From: OJ Ojinaga <oj.ojinaga@ghd.com>
Sent: Saturday, January 25, 2025 10:54 AM
To: Holt, Michael (he/him/his); Gray, Jane K - DNR
Subject: CW3 Shutdown Proposal
Attachments: 003978Bianchin-40-CW3 Proposal (lf).pdf

**Re: City of Wausau New Drinking Water Treatment Facility
and Changes to the Treatment of City Well CW-3
Wausau Water Supply NPL Site
Wausau, Wisconsin**

E. WAUSAU AVENUE
N. 2ND ST RR TRACKS TO WISCONSIN RIVER
WELL NO.3 STORMWATER CONNECTION PLAN

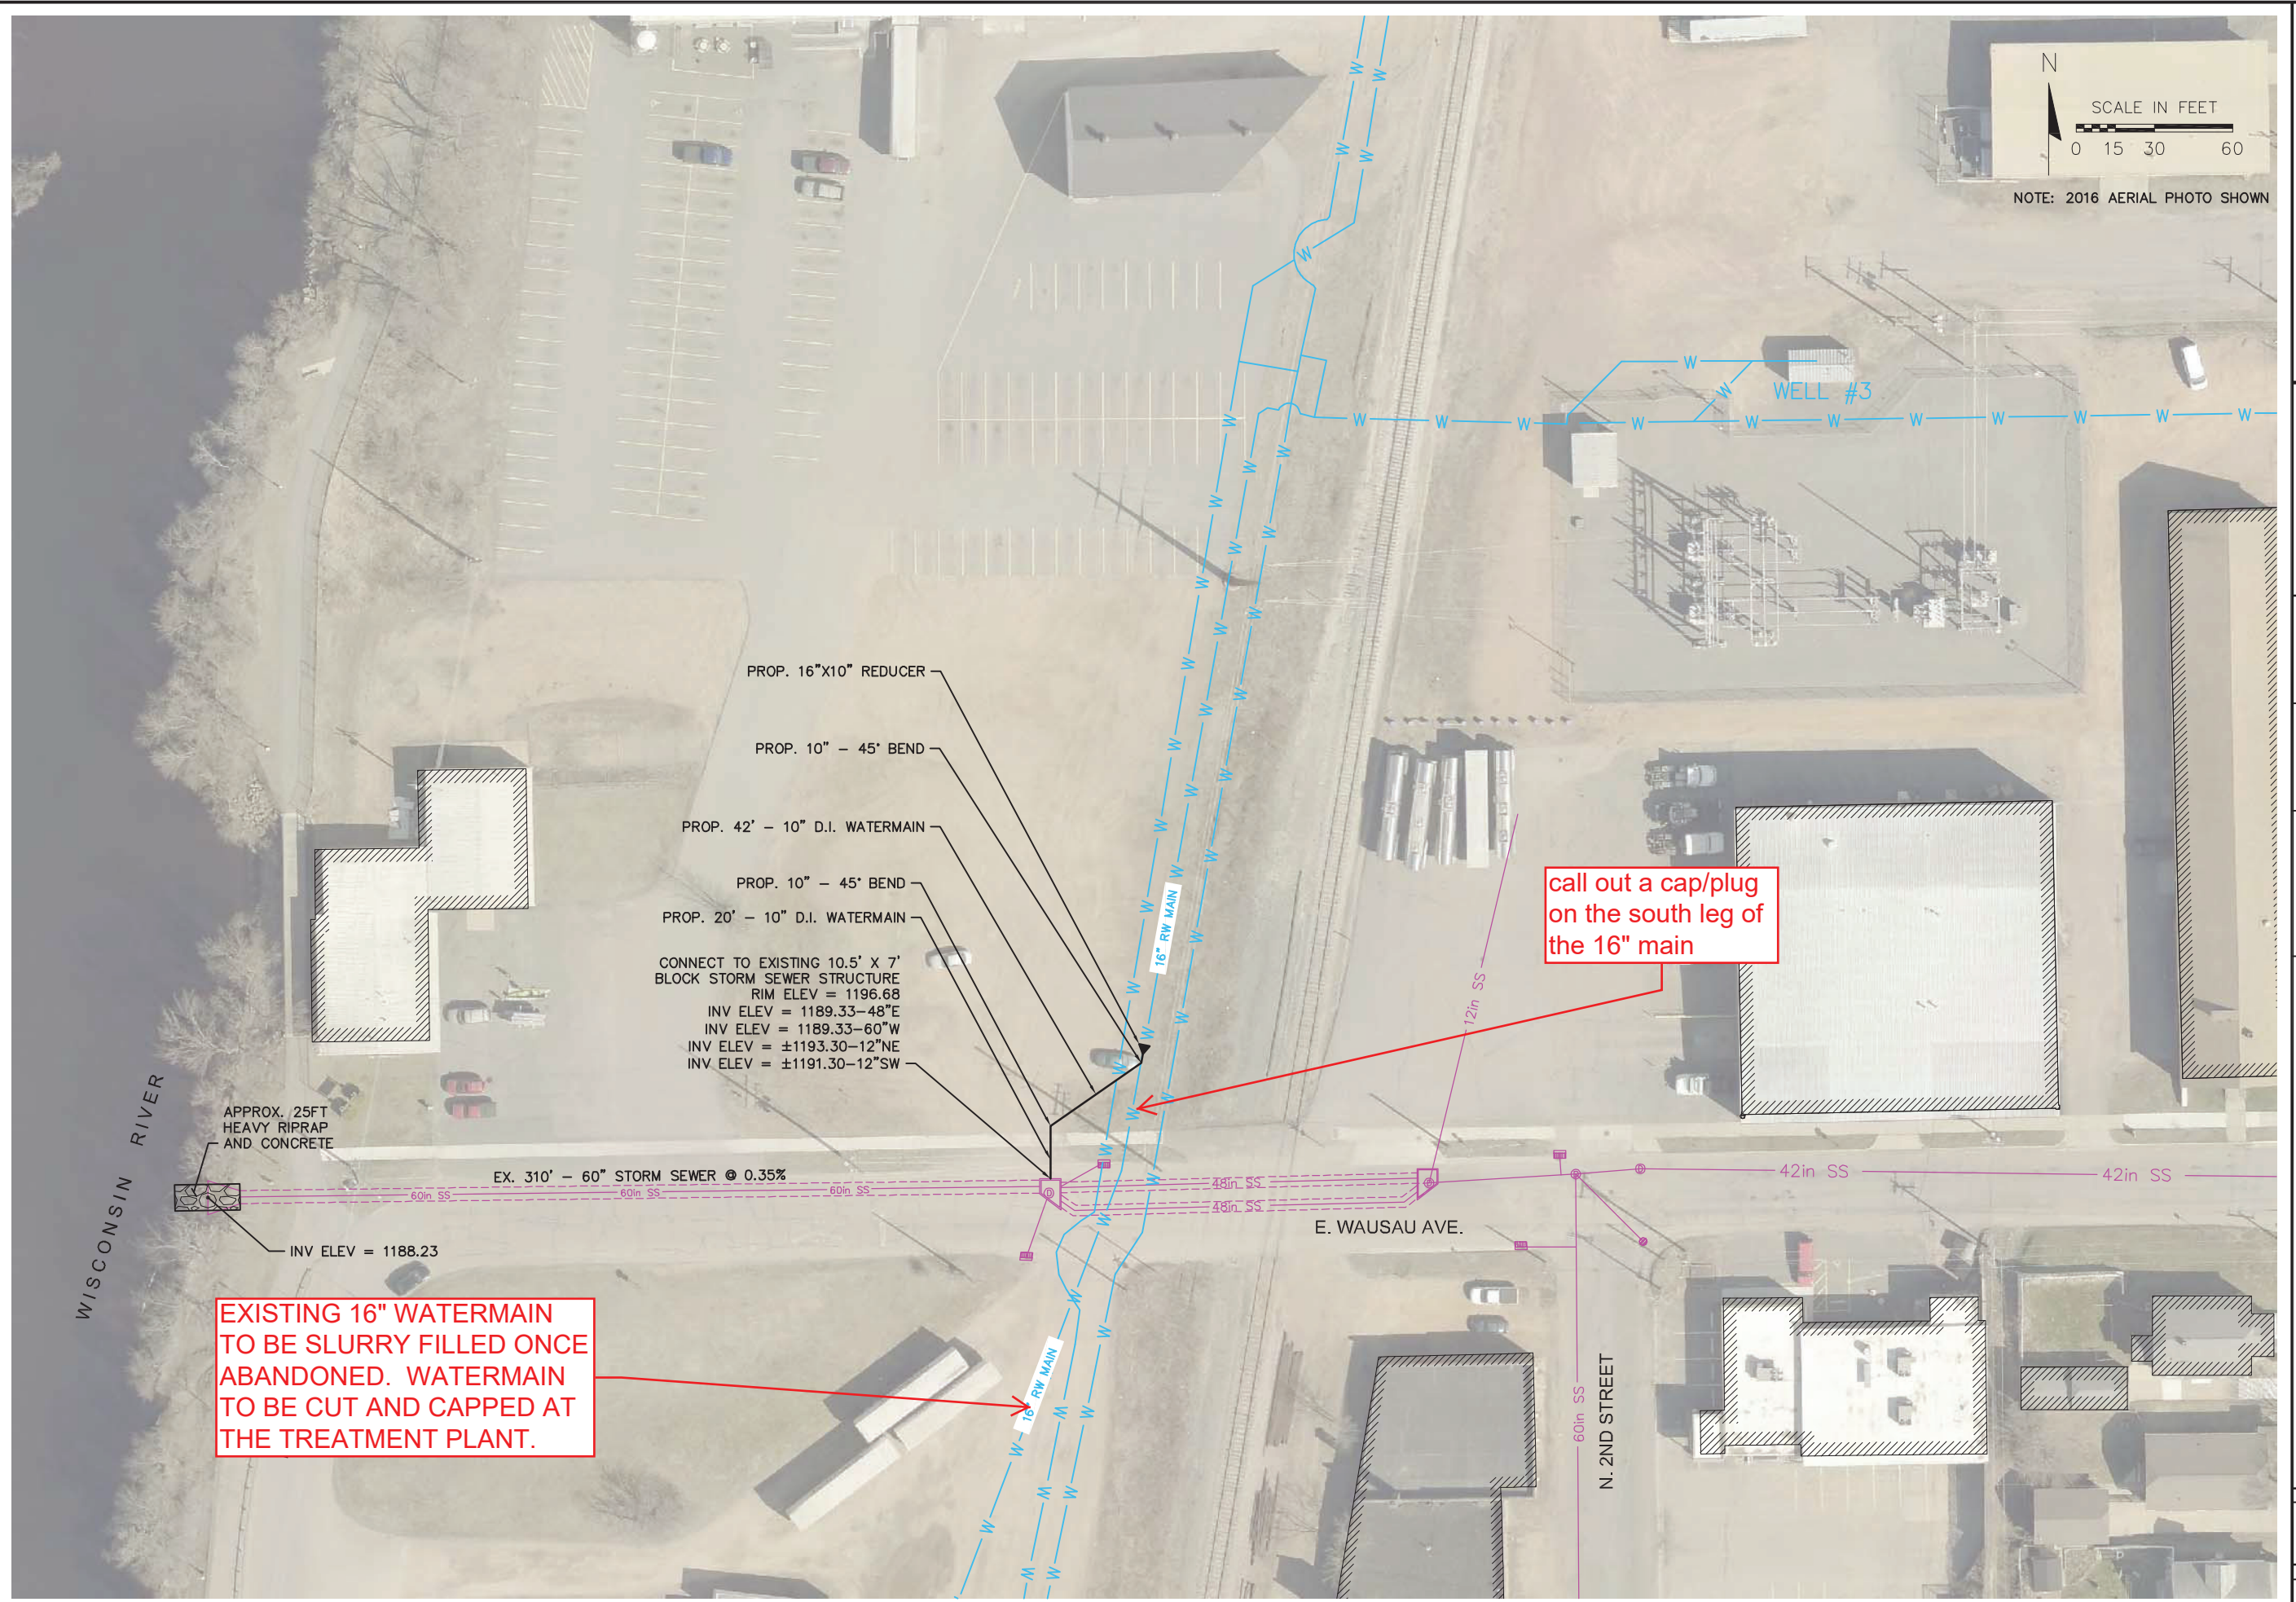
call out a cap/plug on the south leg of the 16" main
